HISTORIC PRESERVATION COMMISSION REGULAR MEETING

2. **Sherman Hotel - Major Certificate of Approval** - The applicant, Greg Kenny, is requesting approval to remove three (3) windows and expand the openings to accommodate a single door in each opening at the Sherman Hotel located at 121 G Street.

STAFF REPORT

AGENDA ITEM TITLE: Sherman Hotel Major Certificate of Approval – 121 G Street

A.2

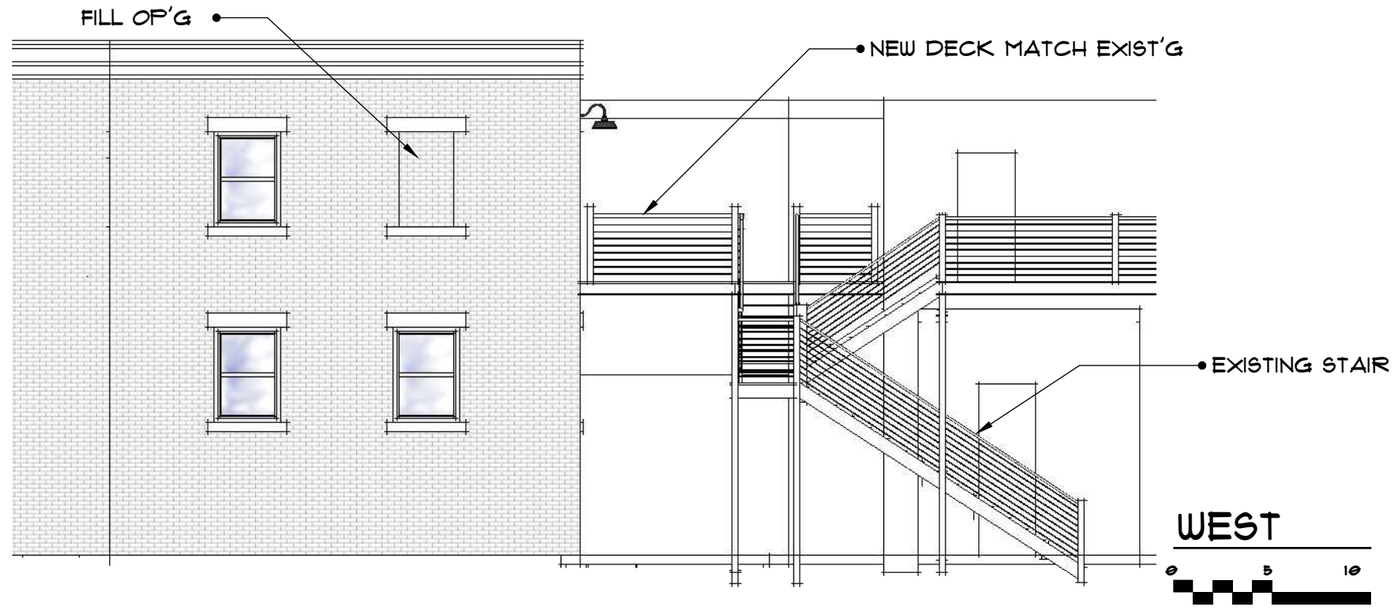
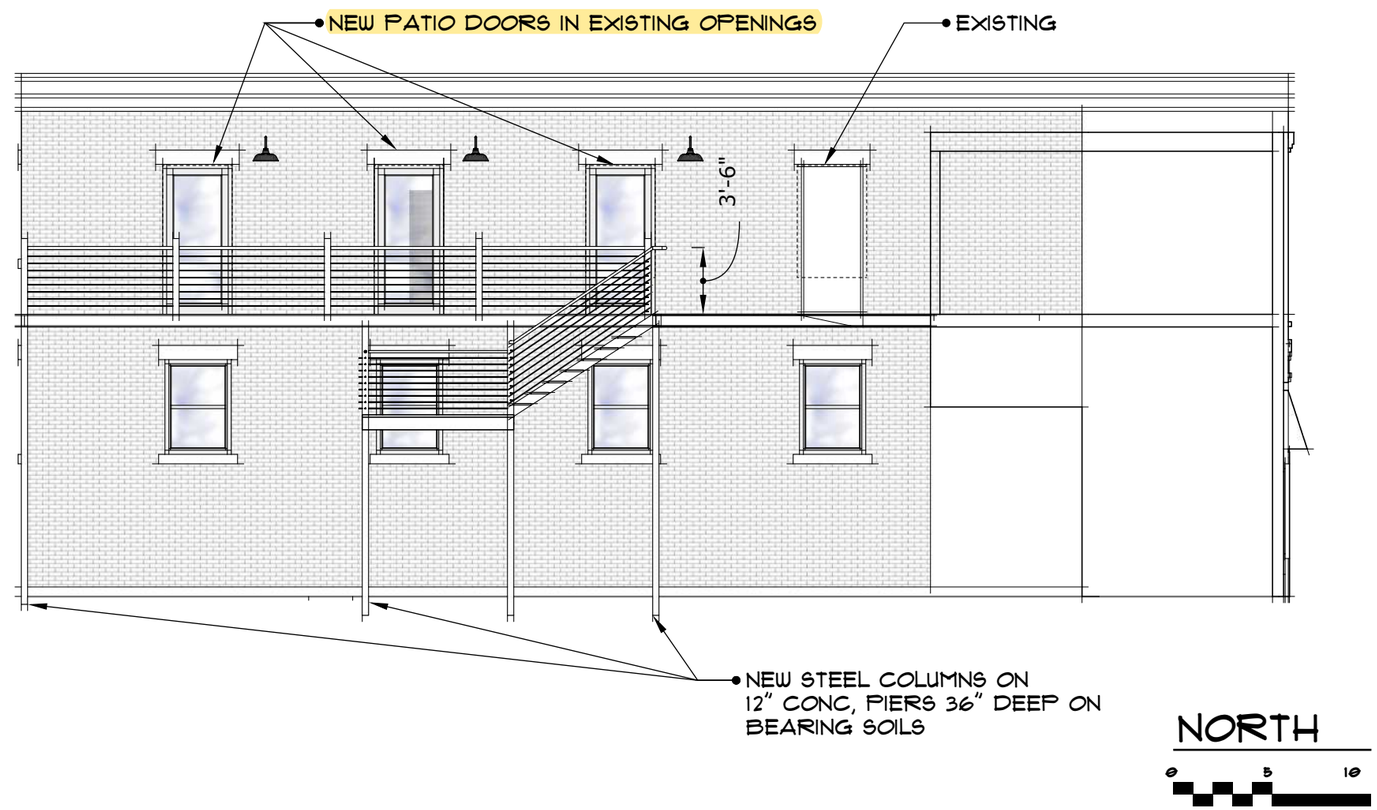
3. Per HPC's request on June 23rd, the applicant has modified their request for expanded door openings and is now requesting 3 door openings that will be the same with as the current windows they will be replacing. The door style is to match the 2nd floor exterior doors on the adjacent building (151 First Street) that face the same courtyard.

1. **Architectural Character.** Whether and/or to what extent the proposed work will preserve, protect, change, diminish, disguise, obscure, detract from or destroy the appearance or structural integrity of the historic features, design, materials, character or value of the structure or site.
   - The applicant is proposing to elongate three existing windows to create exterior door openings that would open out onto a previously approved balcony. According to Part 3, Section C of the Salida Design Guidelines; making a window opening into a door opening is preferable to installing a new door opening.

similar appearance to the original door. The proposal is to match the doors that were previously approved at this site and are currently being utilized as the second floor balcony doors facing this same courtyard from the 151 First Street Building. This is a photo of the current and proposed door:

1. That the Commission **APPROVE** elongating three window openings to accommodate doors that match the existing 2nd floor balcony doors on 151 West First Street.

A.1

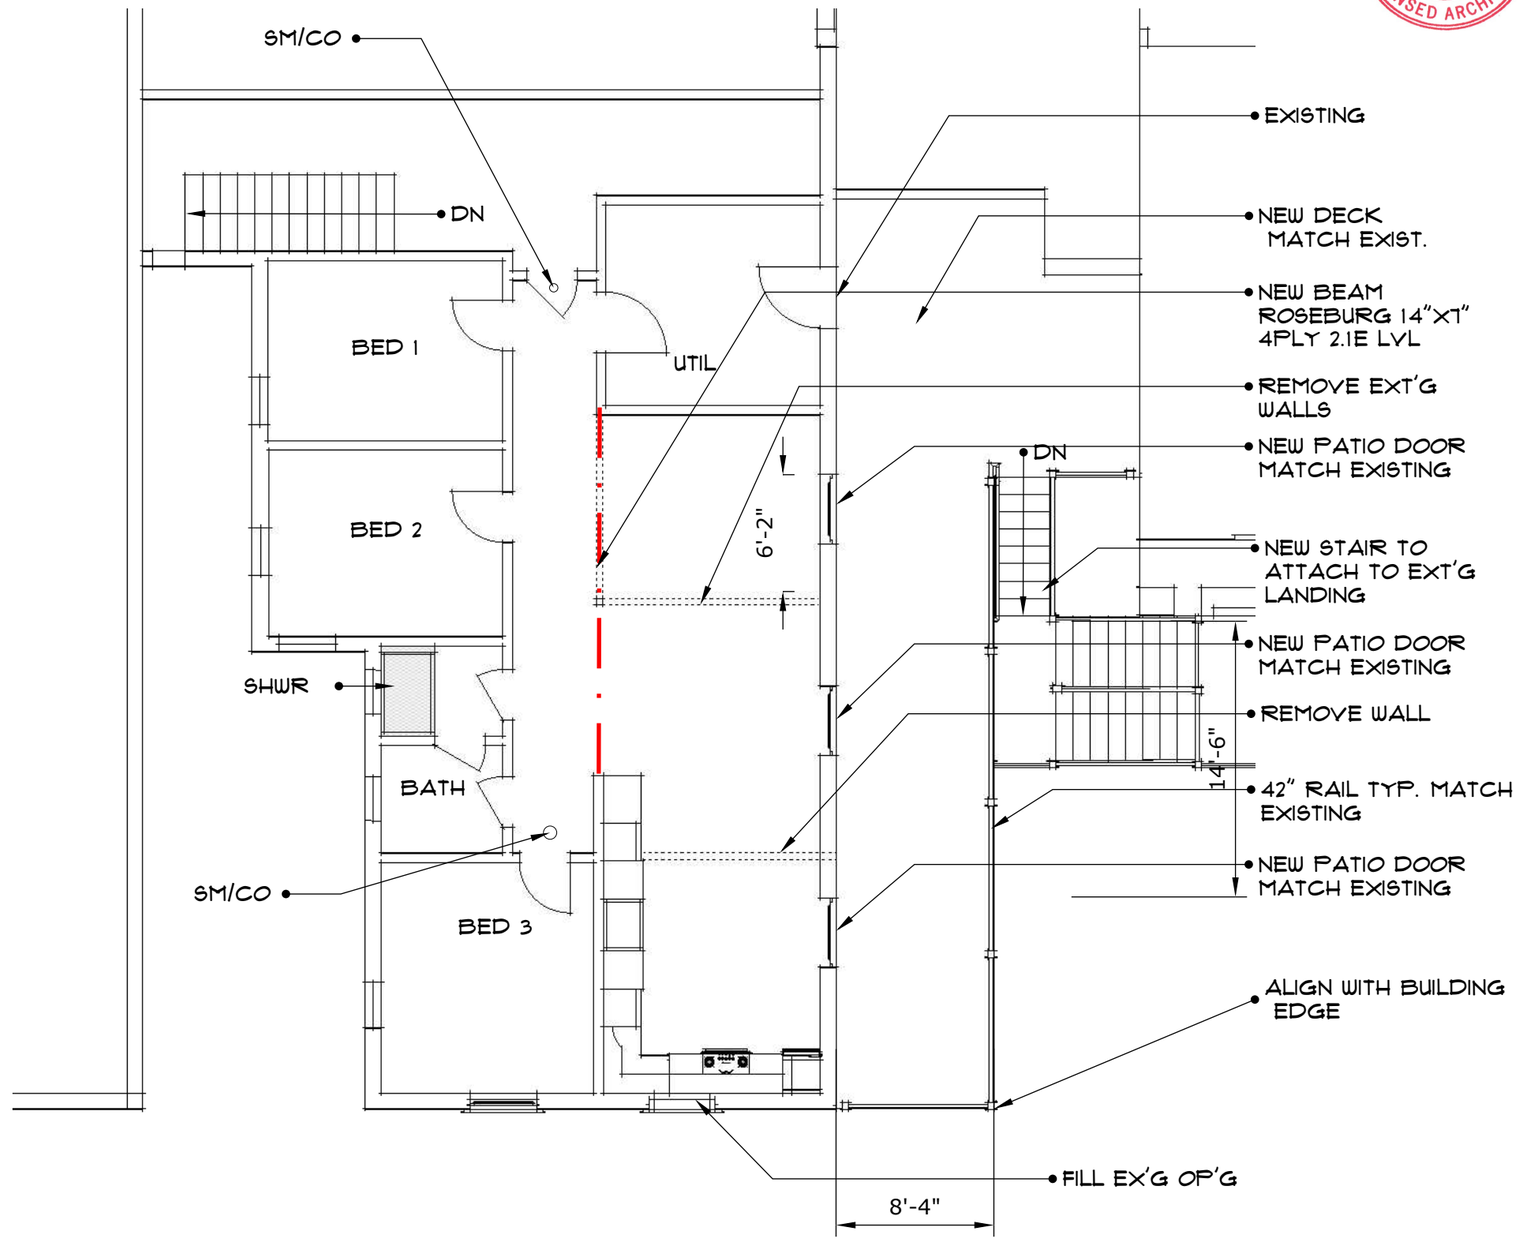
2. The applicant is in the process of remodeling an existing office on the second floor of the building into a living unit, and is requesting this change as part of that remodel.
